Access Compliance Report

Public Rights-of-Way

Intersection ID: 15055	Main Street: BUCHANAN_ST	Cross Street: SCOTT_AV	Location:	N
ADA ID: DA0745C48EA3	Ramp Type: BlendTrans1	Initial Pass/Fail: Pass	Overall Compliance: No	Severity Score: 0

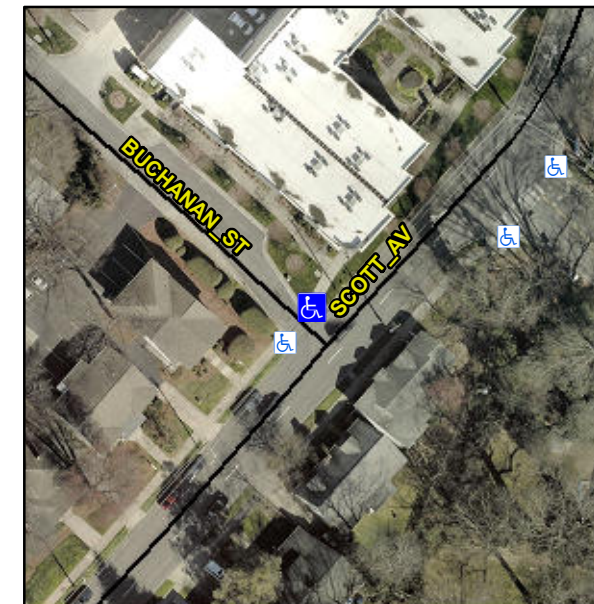
Not Found, R305.2

Remove & Replace Curb Ramp With Two New Directional Ramps or Equivalent.
